Legacy NAA Apartments Construciton Site Inspection

Site: Legacy NAA Apartments: Alameda and San Pedro

Re: Drainage Ordinance (14-5-2-1) Violations for Erosion and Sediment Control

No track-out pad onto San Pedro Blvd. Sediment in street.

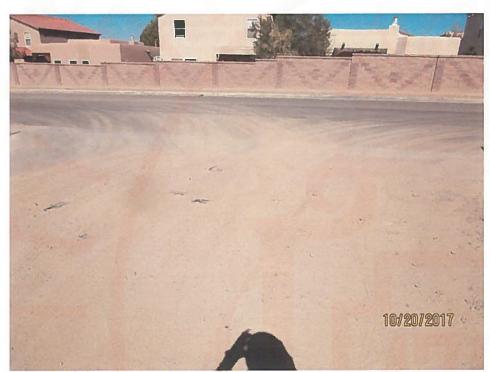
- 1. Three exit locations from the site without stabilized construction entrances (track-out pads).
- 2. Sediment in San Pedro Blvd and Oakland Ave.
- 3. Silt fence not buried.

1. Install stabilized construction entrances (track-out pads) at all locations where vehicles are leaving the site per the approved Erosion and Sediment Control plan details. Currently workers are exiting the site in three locations. The laydown yard/parking lot west of the buildings is part of the site.

2. Remove sediment from San Pedro Blvd and Oakland Ave. along the frontage

Sediment BMP not installed.

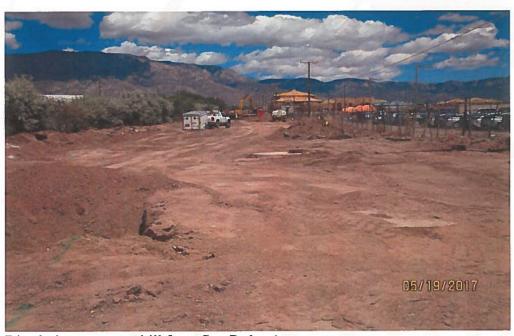
At today's inspection, the sediment BMP had not been installed at the west end of Oakland Ave.

1. A sediment BMP (e.g. filter sock or wattle) shall be placed at the west end of Oakland/east edge of San Pedro. Extend BMP 50 feet south of Oakland on the east side of San Pedro.

Track-out pad/stabilized construction entrance in poor condition.

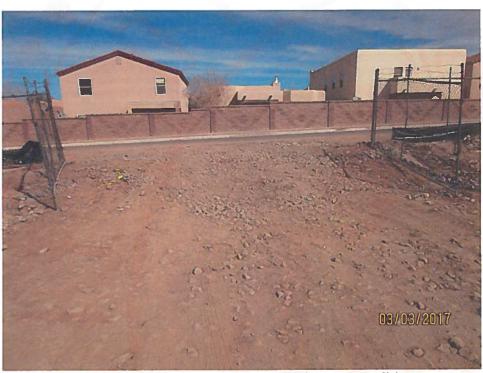
- 1. The Track-out pad/stabilized construction entrance was in poor condition and was required to be replaced.
- 2. Remove sediment from the gutter along the north side of Oakland Ave.

- 1. Install a stabilized construction entrance per the approved Erosion and Sediment Control Plan.
- 2. Remove sediment from the gutter along the north side of Oakland Ave from this site's entrance to the east side of the drive pad shown in the photo below.
